CHAPTER - 34 HIGHLIGHTS (Summary of Changes)

Revision No. TR34-11 Sep 30/20

TO: HOLDERS OF THE AIRCRAFT MAINTENANCE MANUAL (06-123838)

Pitot/AOA Probes - Removal/Installation
Figure 401 (Sheet 1 of 4)

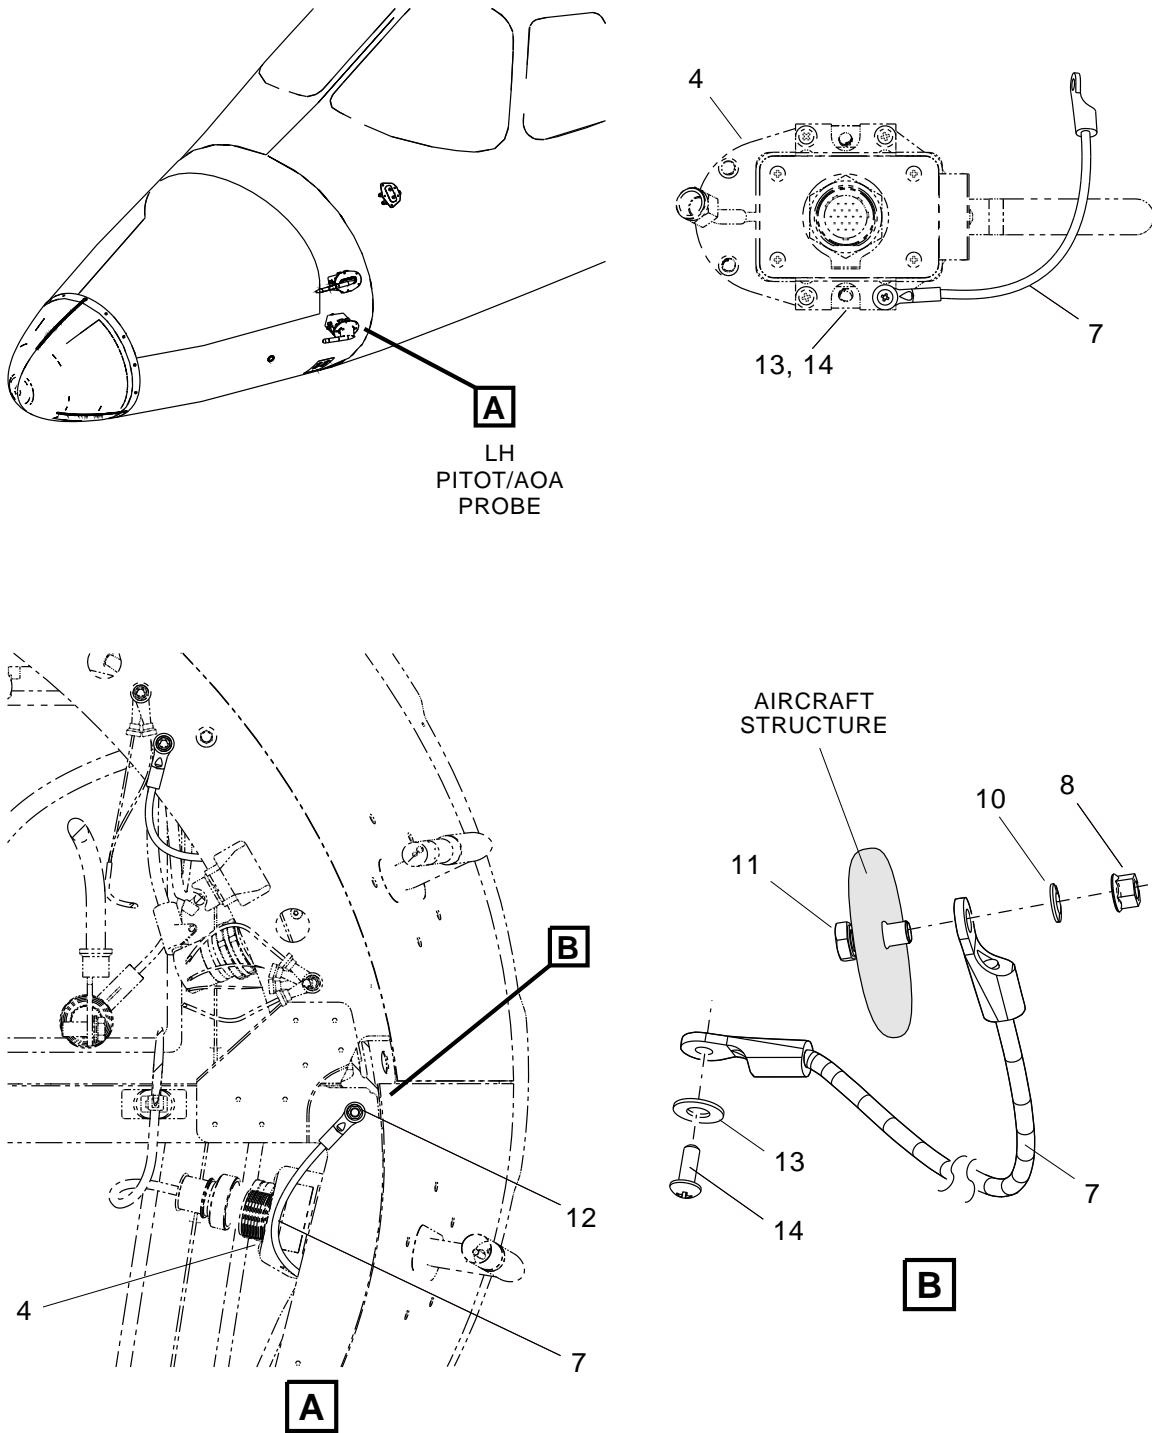
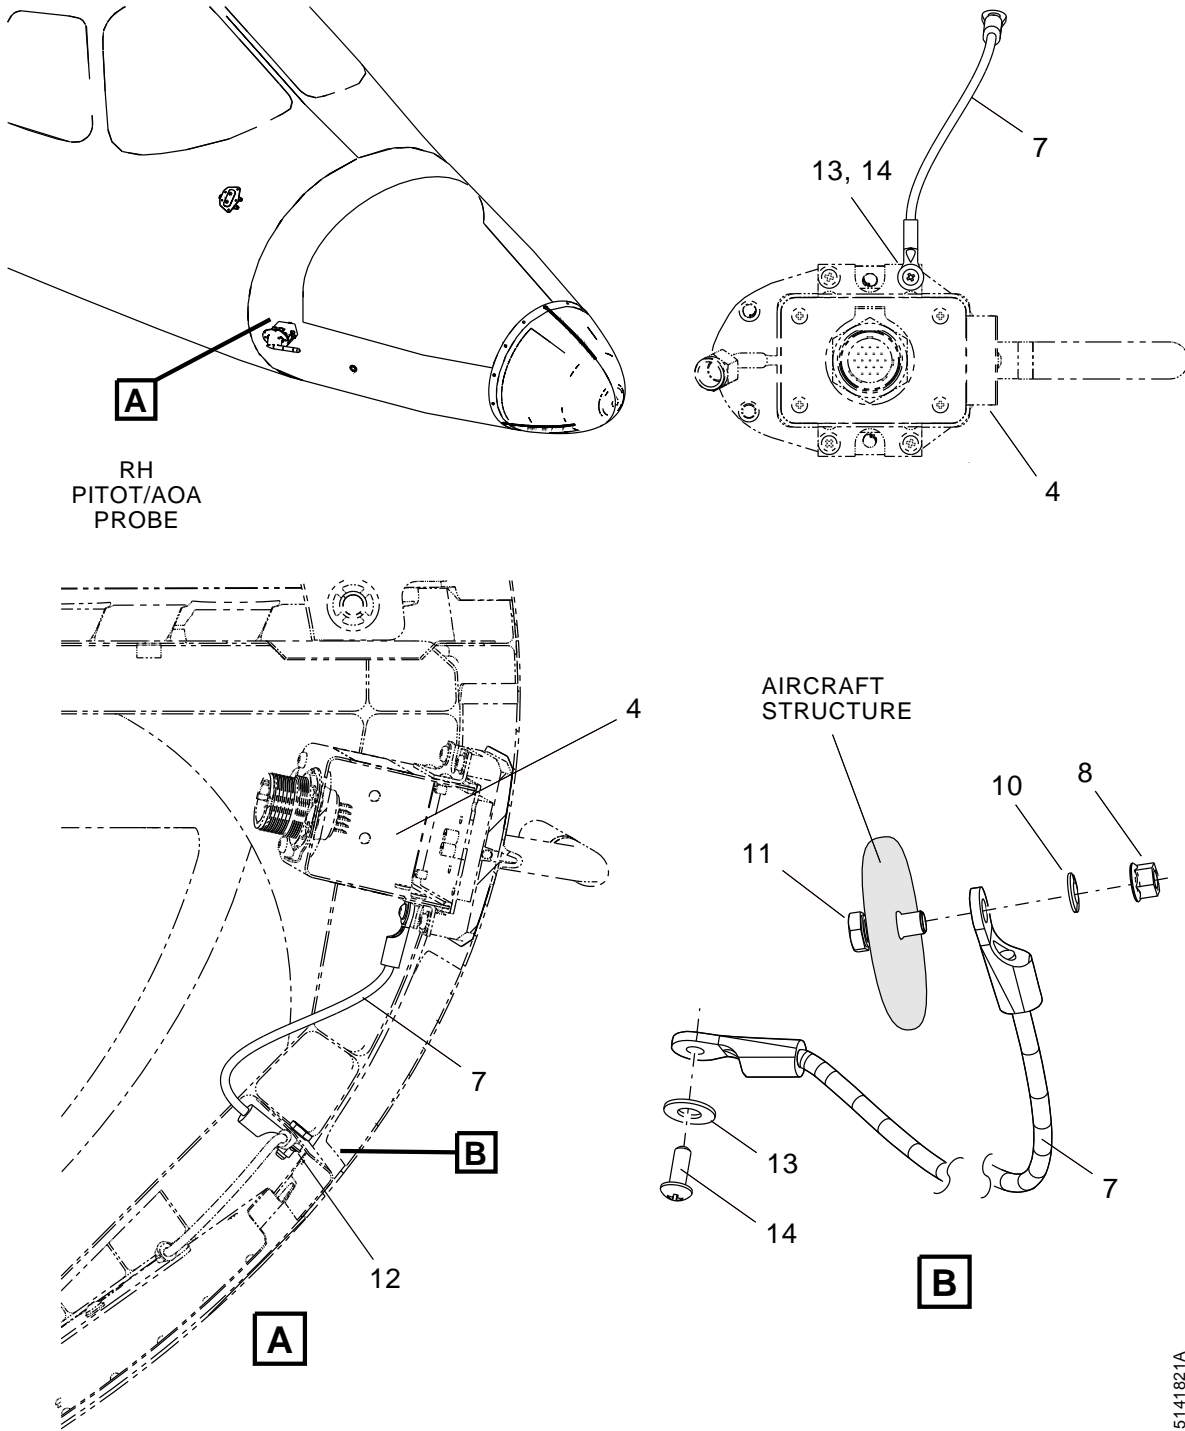
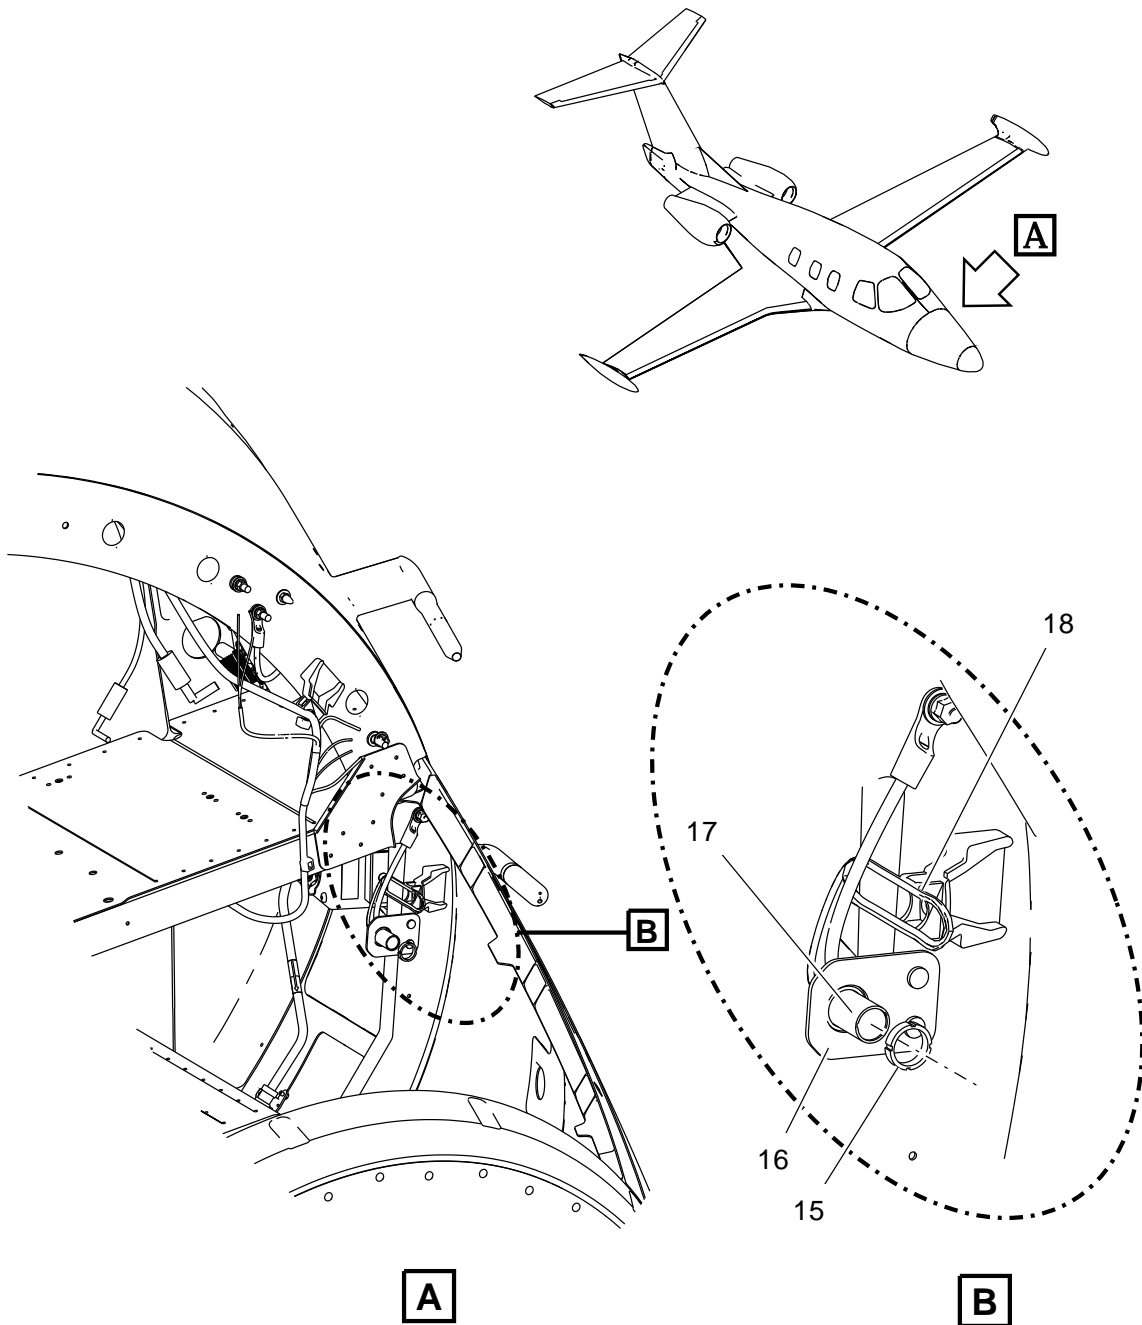
| CH/SE/SU Page Block No. | Description of Change |
|-----------------------------------|---|
| 34-10-10 PgBlk 401-Rem (C) | Added auxiliary heaters to Pitot/AOA Probe - Removal - Config C. |
